Backfeed v261

Changelog:

Figure 145–27a — Detection signature requirements connection configurations

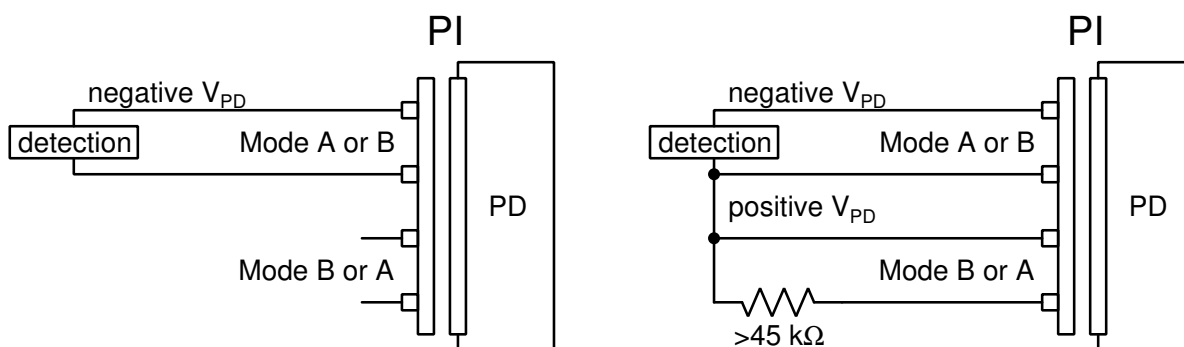
When a PD presents a valid or non-valid detection signature, it shall present the detection signature on each pairset, when probed per any of the valid 2-pair configurations defined in Table 145–20. In addition, one pair denoted with “—”, is connected to the positive potential with any series resistance greater than 45 k Ω (see Figure 145–27a).

Add new Figure 145–27a as follows:

Figure 145–29a — Reflected voltage requirements

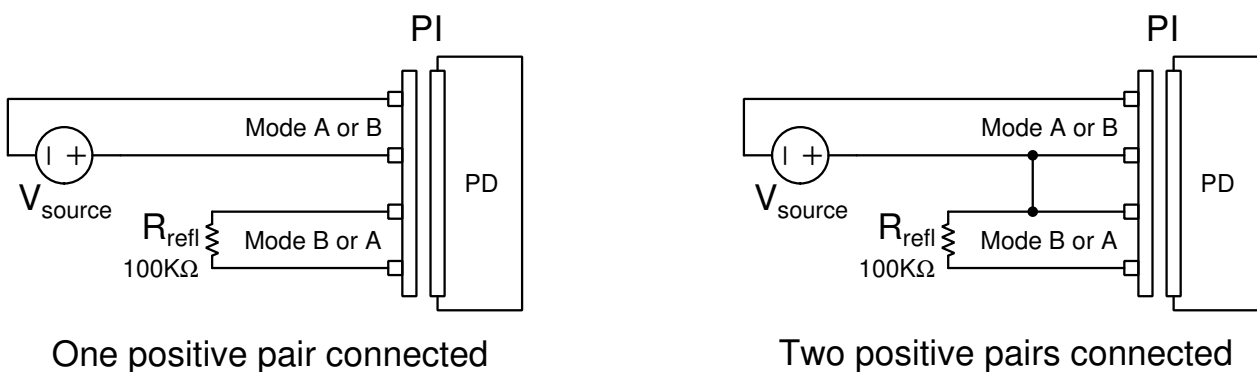
Replace the contents of 145.3.8.8 as follows:

For a single-signature PD, when any voltage in the range of 0 V to $V_{Port_PD-2P\ max}$ is applied per any of the valid 2-pair configurations, defined in Table 145–20, that have only a single pair connected to positive V_{PSE} (see Figure 145–29a), the voltage on the Mode not connected to the voltage source, with a 100 k Ω resistor connected across that Mode, shall not exceed V_{refl} as defined in Table 145–29.

For a dual-signature PD, when any voltage in the range of 0 V to $V_{Port_PD-2P\ max}$ is applied per any of the valid 2-pair configurations, defined in Table 145–20, including those with two pairs connected to positive V_{PSE} (see Figure 145–29a), the voltage on the Mode with at least one pair not connected to the voltage source, with a 100 k Ω resistor connected across that Mode, shall not exceed V_{refl} as defined in Table 145–29.
